PIVOT ARCHITECTURE

ADDENDUM # 5

Project: **Klamath Community College Childcare Learning Center (2331.00)**

Date: September 4, 2025

1 SOUTHEAST ENLARGED ELEVATION
1/4" = 1'-0"

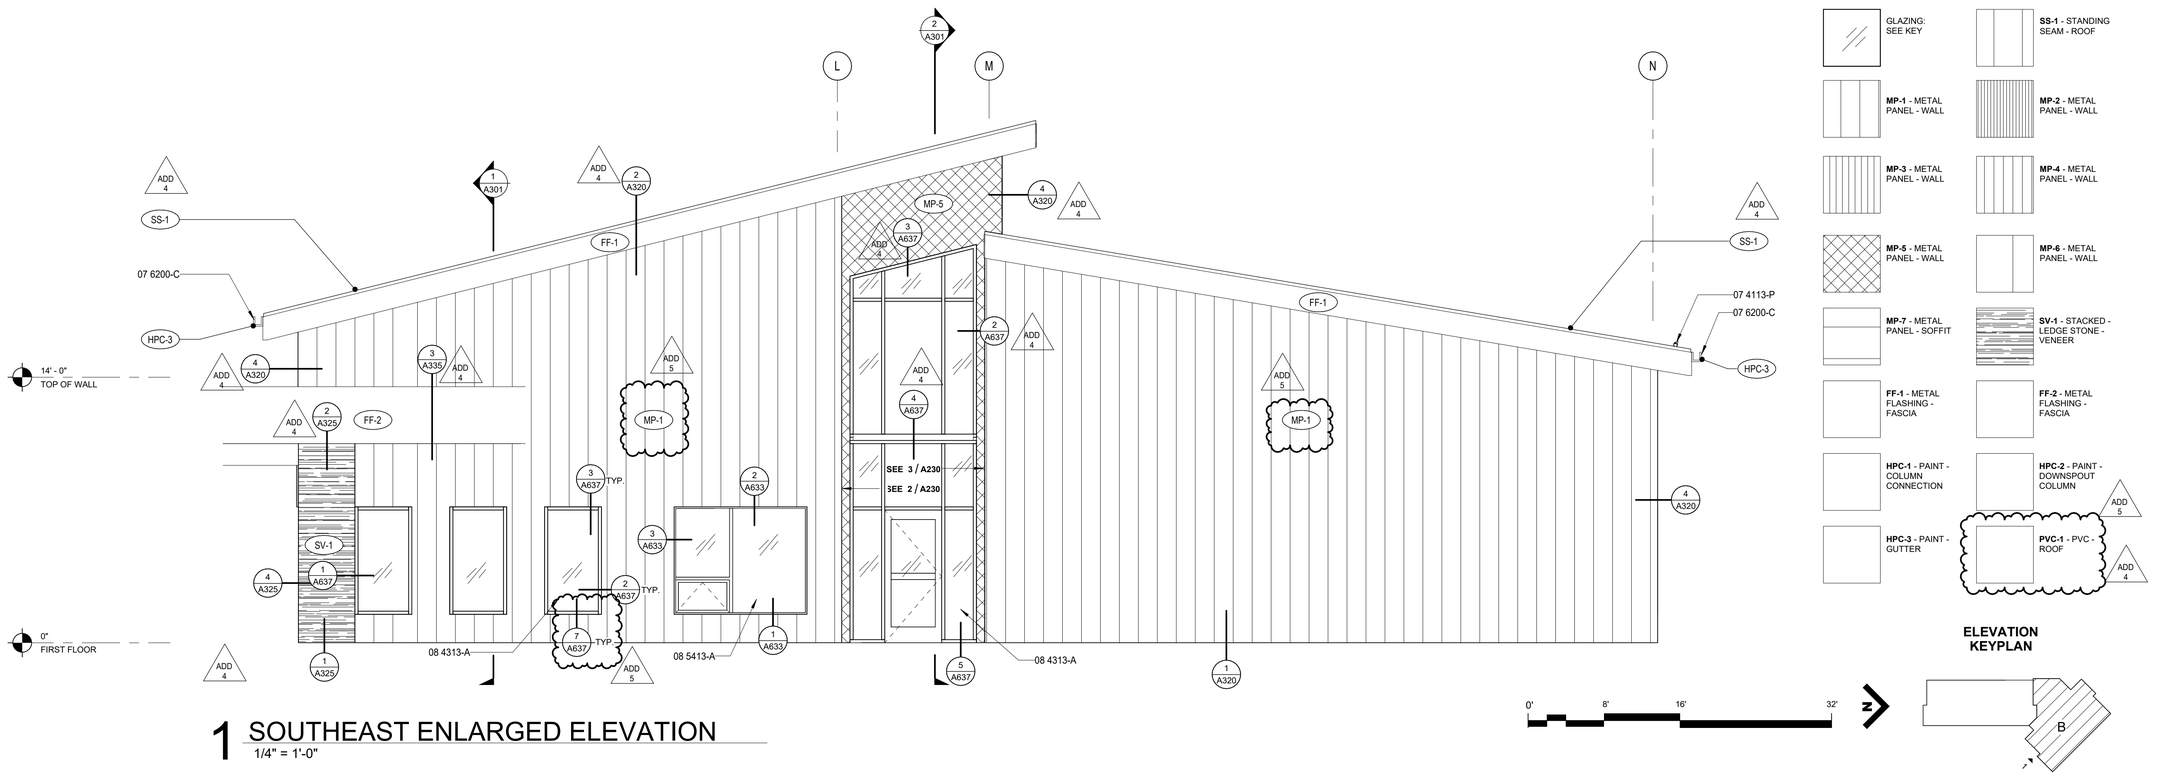
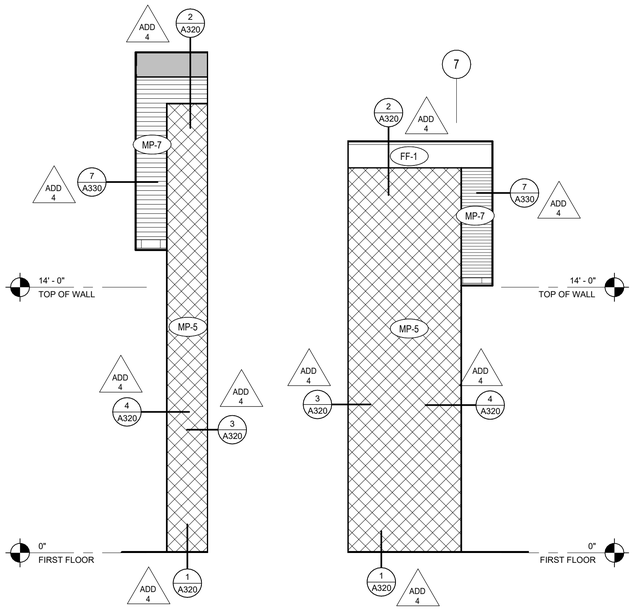
3.18. A230 ENLARGED EXTERIOR ELEVATIONS – SECTOR B SOUTHEAST
- 3.18.1. REVISED, end wall design simplified to one metal profile
- 3.18.2. ADDED, storefront sill detail tag

1 NORTHWEST ENLARGED ELEVATION
1/4" = 1'-0"

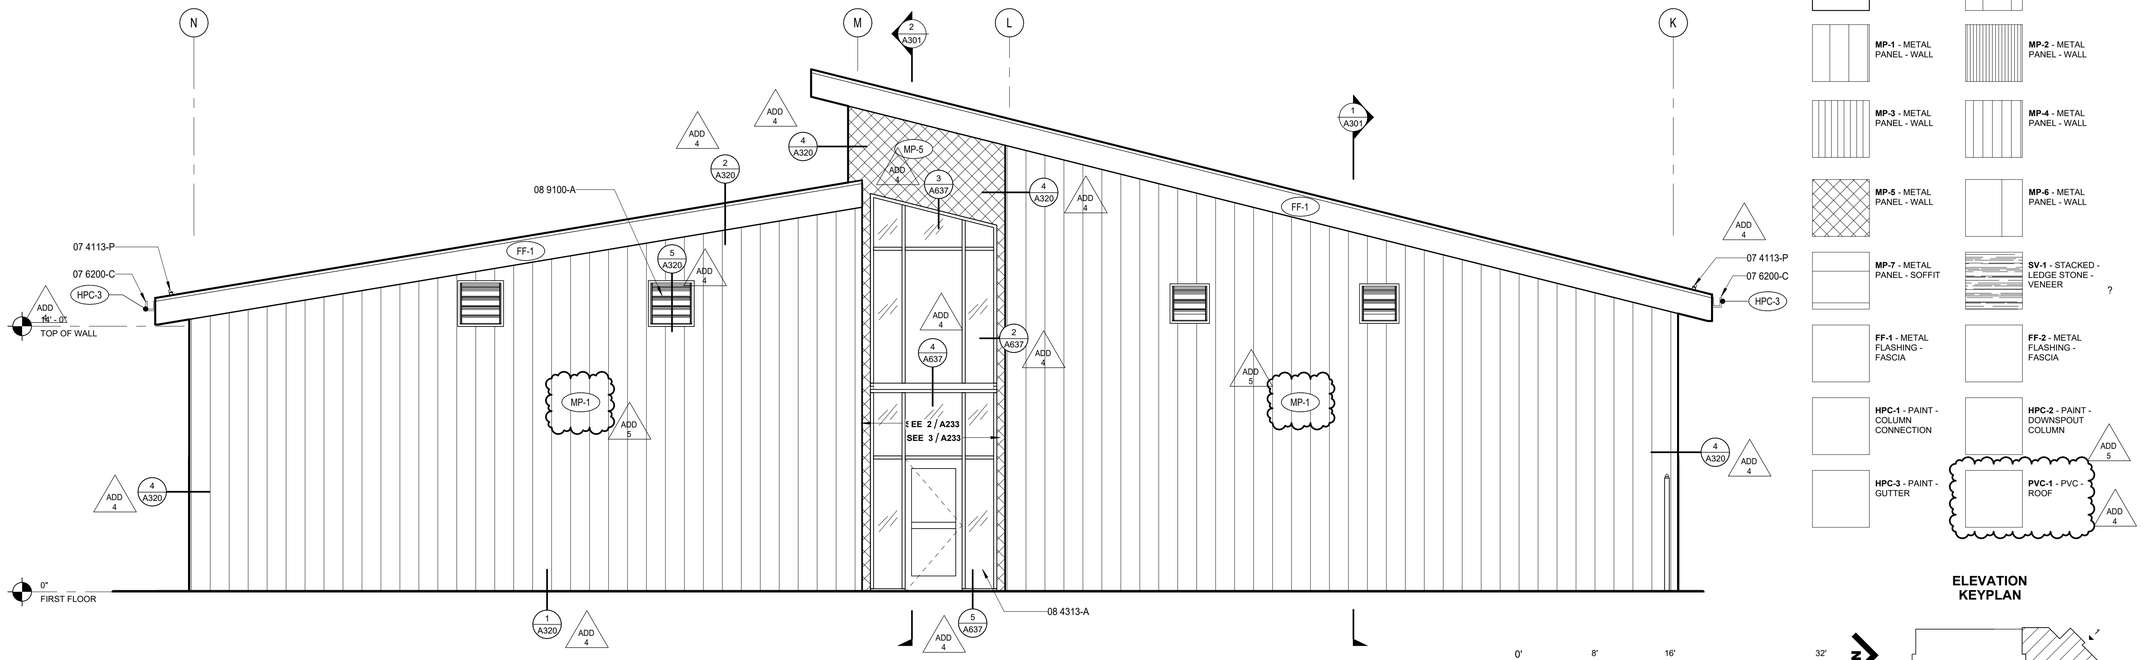
3.19. A233 ENLARGED EXTERIOR ELEVATIONS – SECTOR B NORTHWEST
- 3.19.1. REVISED, end wall design simplified to one metal profile

1 SOUTHWEST ENLARGED ELEVATION

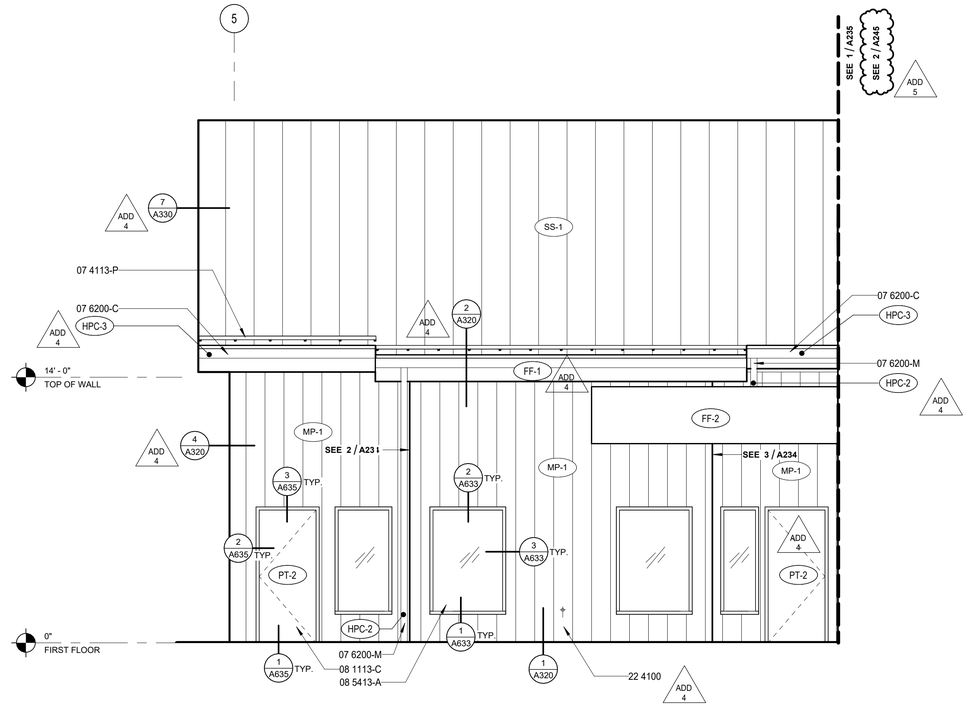
3.20. A234 ENLARGED EXTERIOR ELEVATIONS – SECTOR B SOUTHWEST
- 3.20.1. ADDED, view reference to match line for low roof elevations

2 WEST ENLARGED ELEVATION - COMMONS

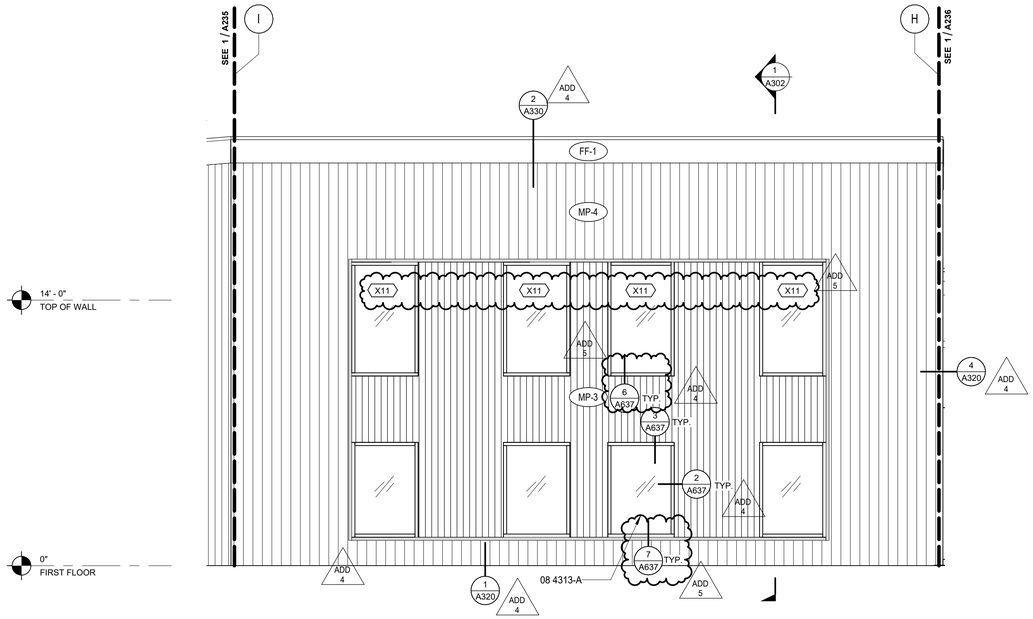
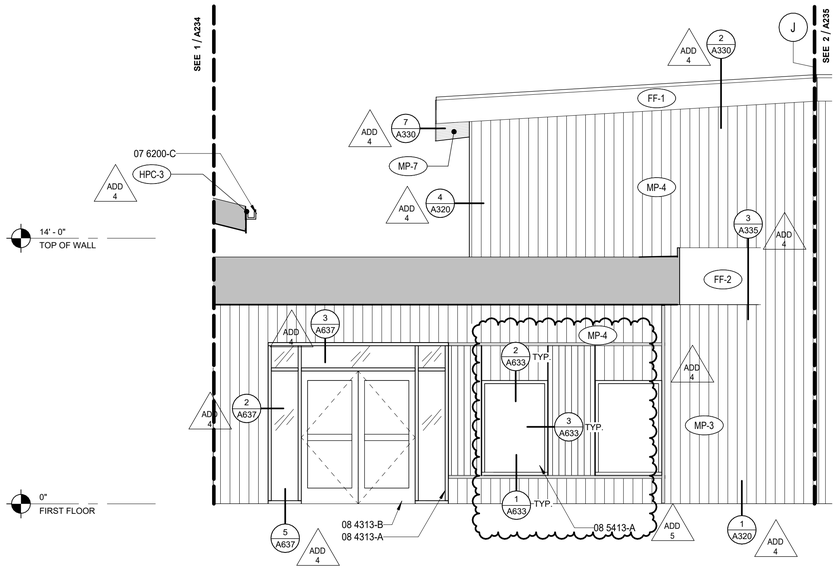
3.21. A235 ENLARGED EXTERIOR ELEVATIONS – SECTOR B COMMONS
- 3.21.1. ADDED, window detail tag
- 3.21.2. ADDED, Storefront type tag

1 WEST ENLARGED ELEVATION - A

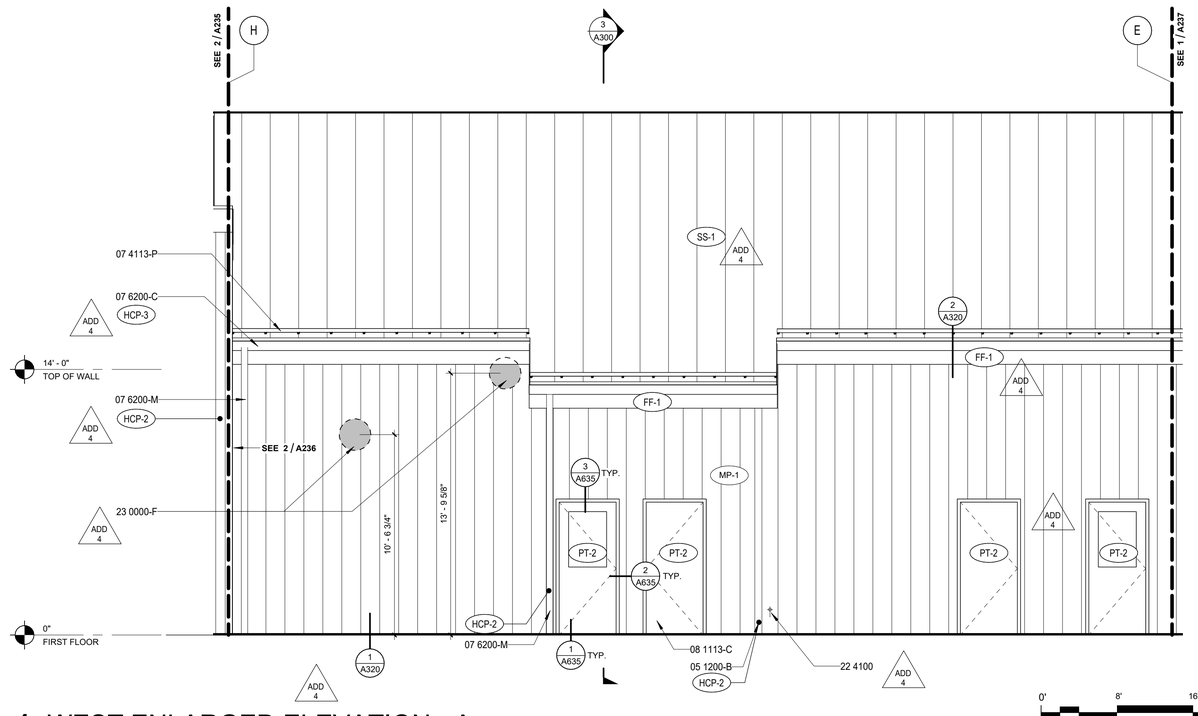
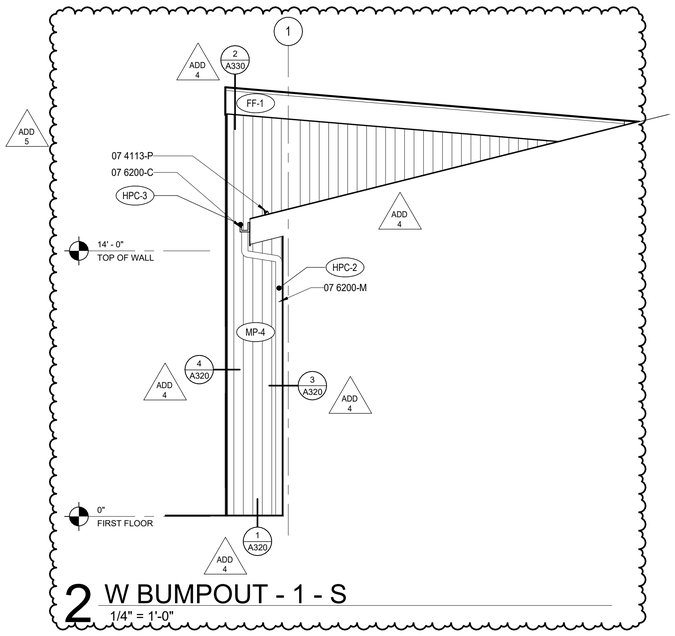
3.22. A236 ENLARGED EXTERIOR ELEVATIONS – SECTOR A WEST - A
- 3.22.1. REVISED, enlarged elevation to show more wall and conditions

1 SOUTH ENLARGED ELEVATION

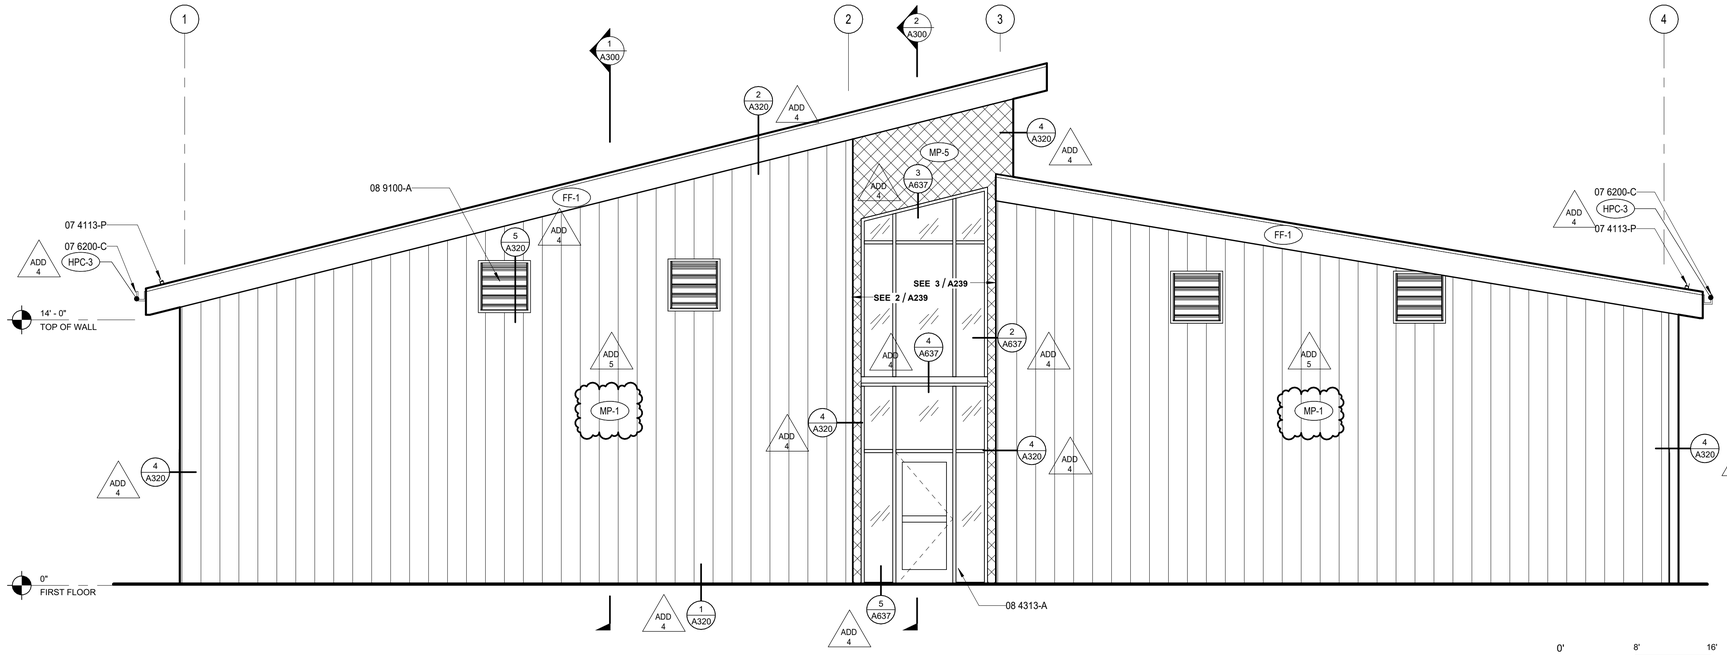
3.23. A239 ENLARGED EXTERIOR ELEVATIONS – SECTOR A SOUTH
- 3.23.1. REVISED, end wall design simplified to metal profile

1 SOUTHWEST LOW ROOF ENLARGED ELEVATION - A
1/4" = 1'-0"

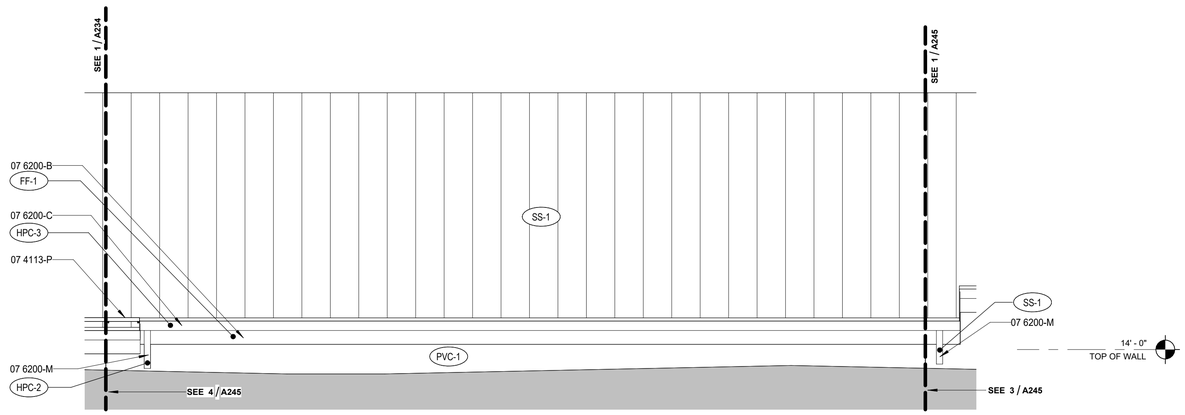
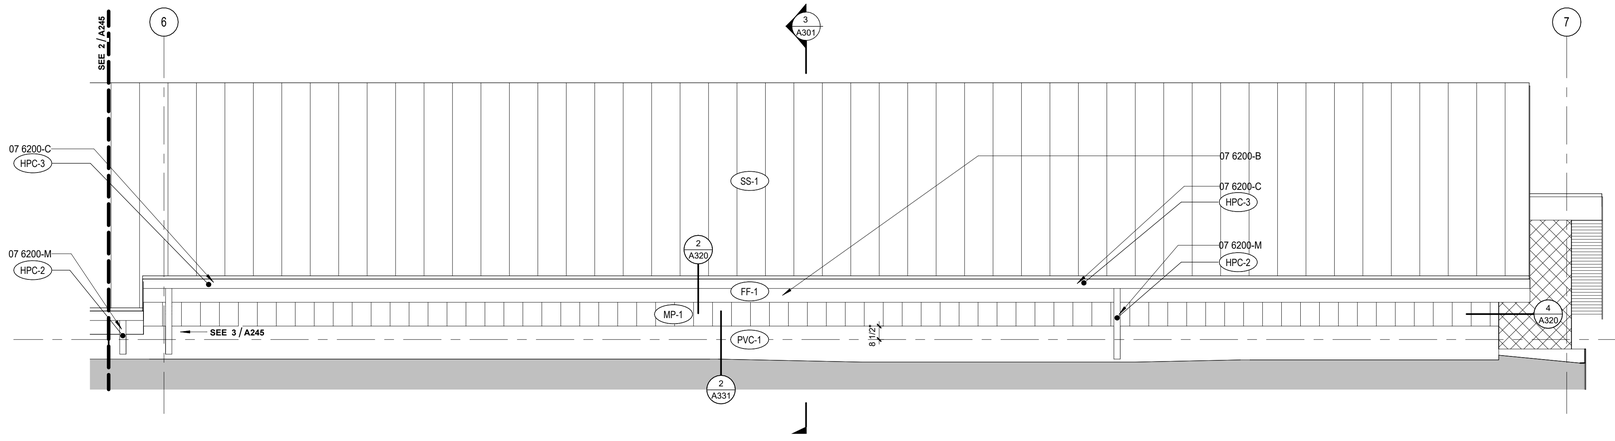
3.24. A245 ENLARGED EXTERIOR ELEVATIONS – LOW ROOF
- 3.24.1. NEW SHEET ADDED, elevations for walls around low roof

3.24.2. ADDED, exterior material tag for PVC roof

1 NORTH LOW ROOF ENLARGED ELEVATIONS
1/4" = 1'-0"

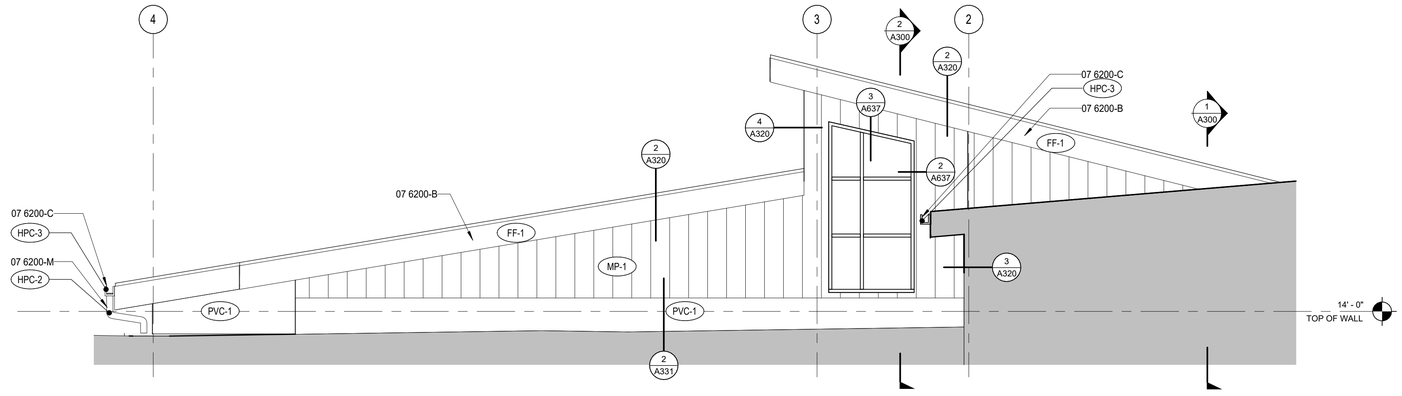
3.25. A246 ENLARGED EXTERIOR ELEVATIONS – LOW ROOF
3.25.1. NEW SHEET ADDED, elevations for walls around low roof
3.25.2. ADDED, exterior material tag for PVC roof

10 102 COMMONS - E
1/4" = 1'-0"

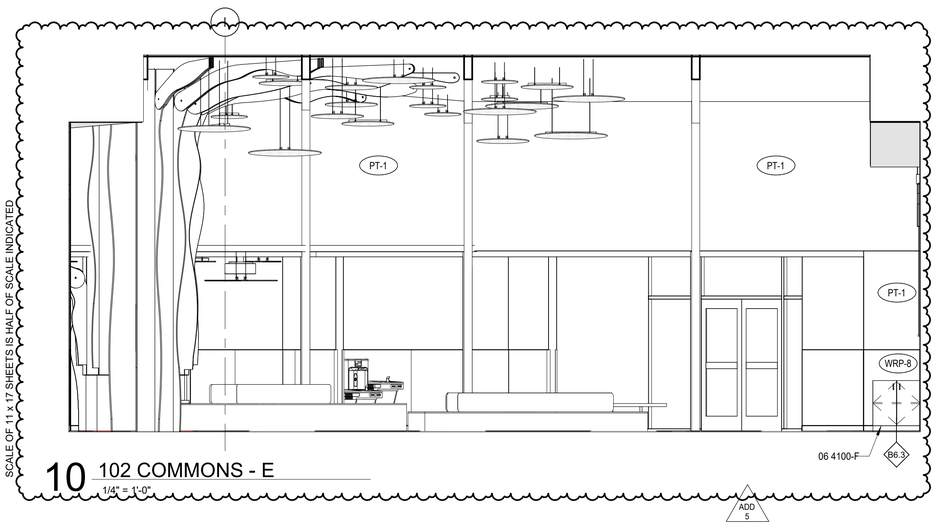
3.31. A542- INTERIOR ELEVATIONS ENTRY & COMMONS
3.31.1. ADDED Elevation 102 COMMONS – E

8 TYP CLASSROOM WINDOW NOOK
1 1/2" = 1'-0"

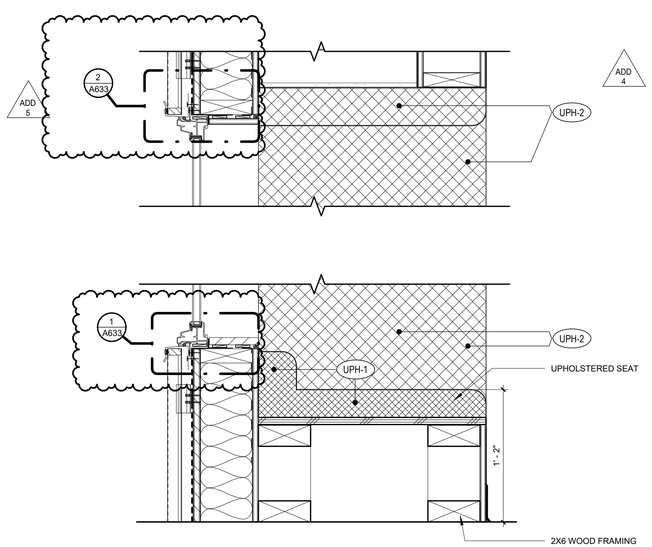
3.34. A571 INTERIOR DETAILS – CASEWORK
3.34.1. ADDED Head & Jamb view references to TYP Classroom Window Nook detail.
